Notice of Intent

Sundry ID: 2654288

Type of Action: Plug and Abandonment

General Information			
Well Name	Mestenas Canyon 1	Date:	1/24/2022
API:	30-039-27677	AFE #	
Field:	San Juan	County	San Juan
Status:	Well is ACOI		
Subject:	Permanently P&A wellbore		
By:	M. Wissing

PROPOSED WELLBORE SCHEMATIC

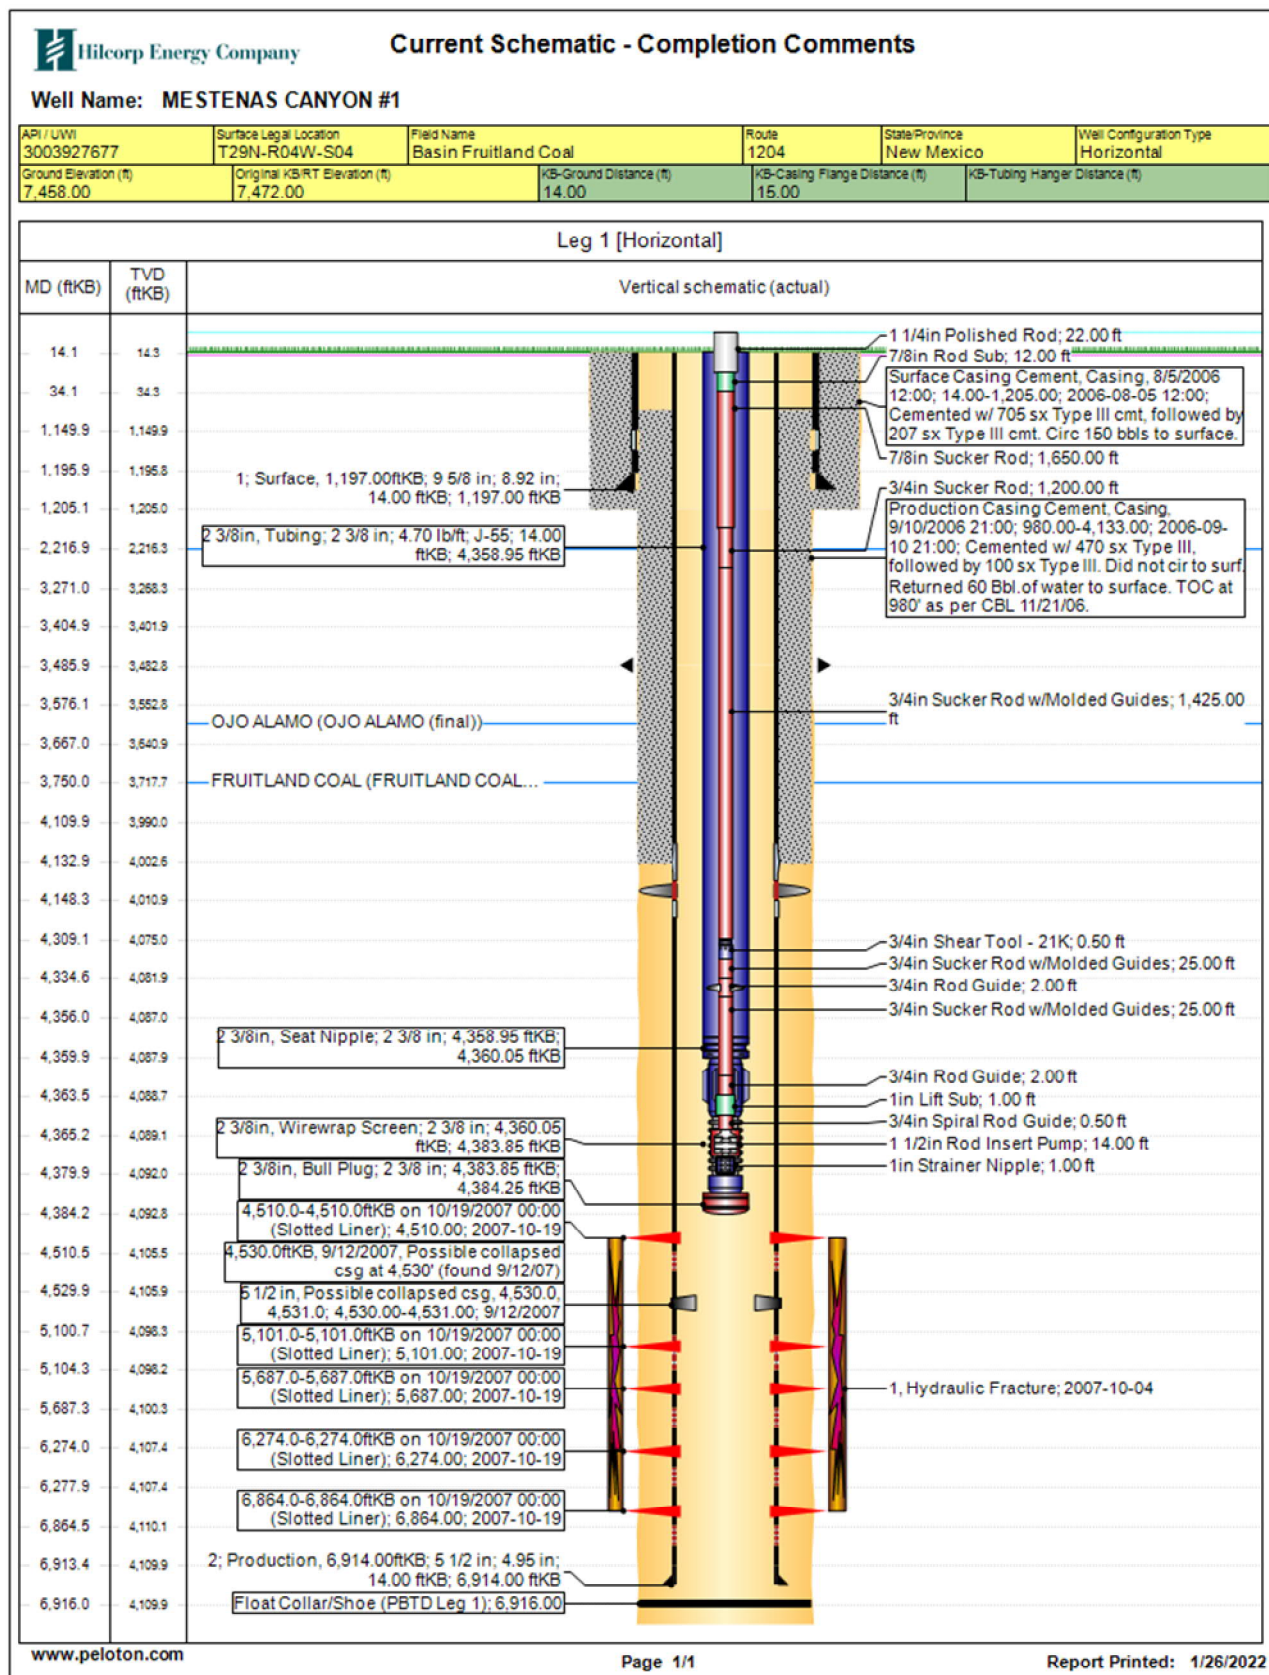
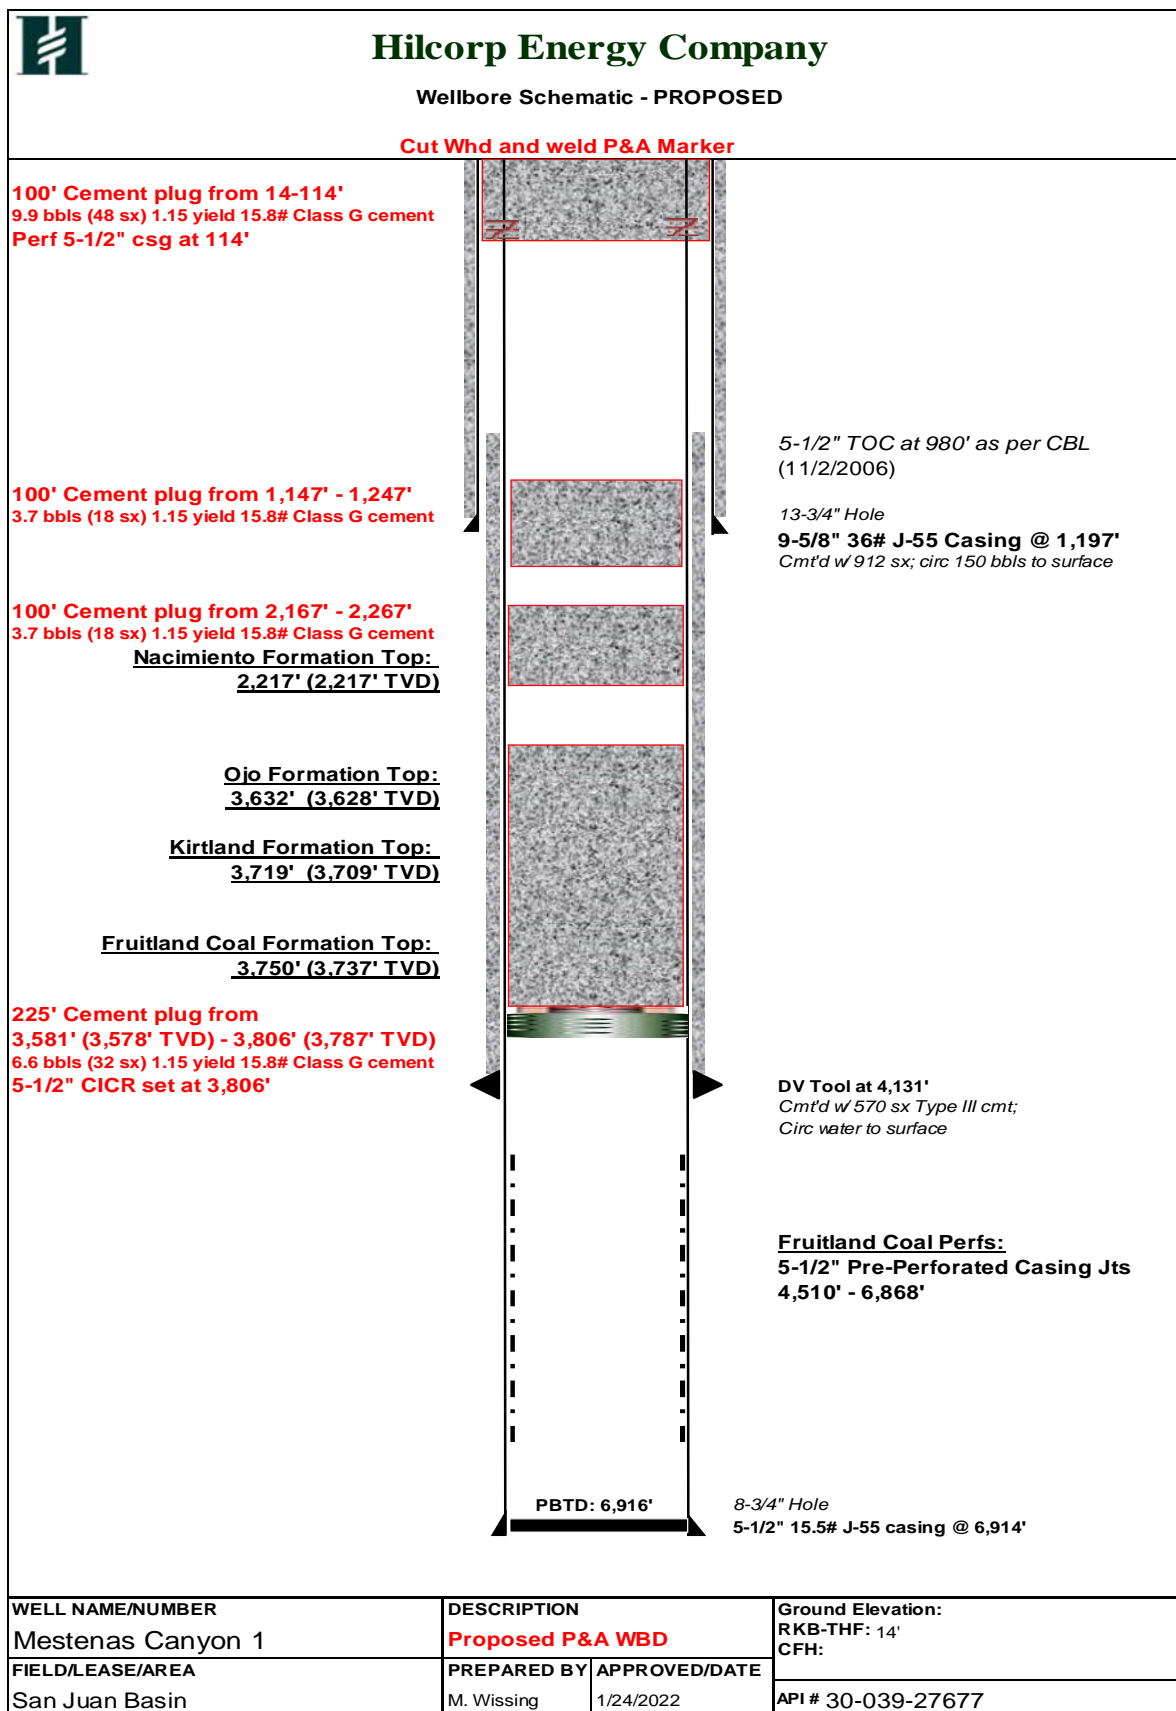
- Horizontal well bore. All formation tops are reported as measured depth (MD) from KB elevation.
- The plugs proposed in the P&A procedure will adequately protect any freshwater sands in this well bore.
- Fruitland Coal 5.5" pre-perforated casing joints set from 4510' – 6864' (MD).

You are also required to place cement excesses per 4.2 and 4.4 of the attached General Requirements.
